ALERT SERVICE BULLETIN

205B-14-63
23 July 2014

MODEL AFFECTED: 205B

SUBJECT: MAIN ROTOR GRIP 204-011-121-009 REVISED
ULTRASONIC INSPECTION AND DAILY SPECIAL
INSPECTION REQUIREMENTS, INTRODUCTION
OF.

Figure 1. Drag Brace Attachment Lugs Inspection

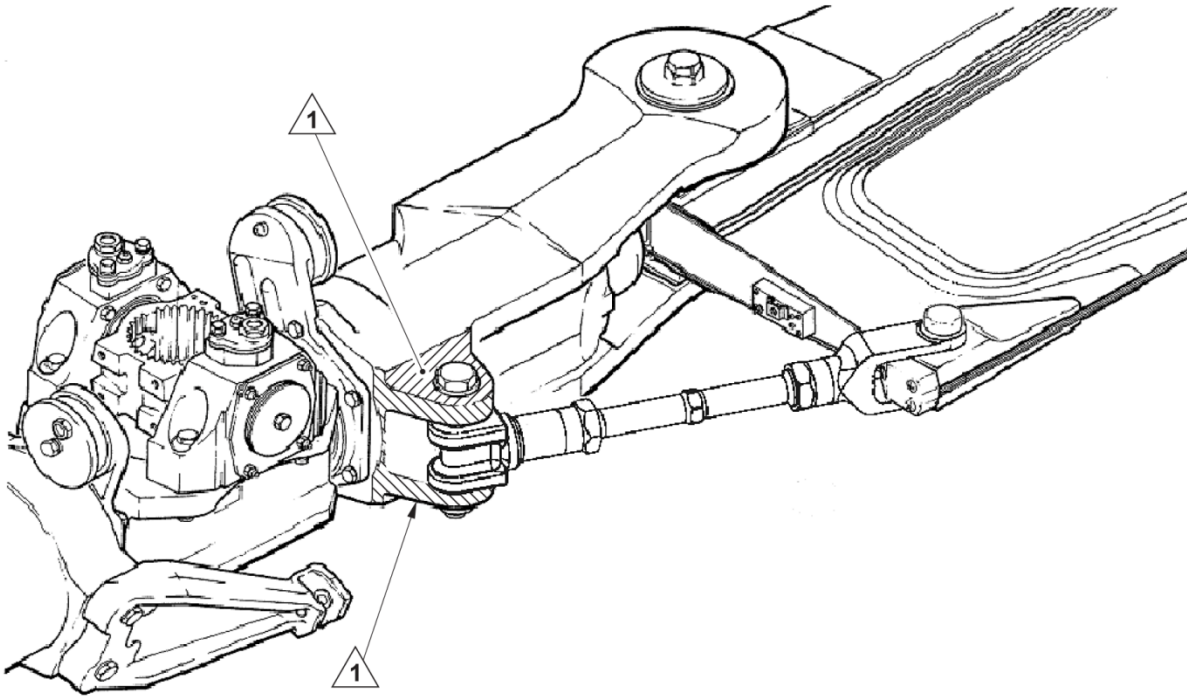
1. Without removing the drag brace attachment hardware, perform a daily visual inspection of the two drag brace attachment lugs on the outboard surfaces at the areas shown in Figure 1.
2. If a crack is found, remove the grip from service.
3. Make an entry in the helicopter and component historical records to indicate findings and accomplishment of **Part II** of this bulletin.

Note 1: Perform a daily visual inspection of the outboard face and edges of both drag brace attachment lugs as shown. Drag brace attachment hardware does not require removal. If a crack is found remove the grip from service.
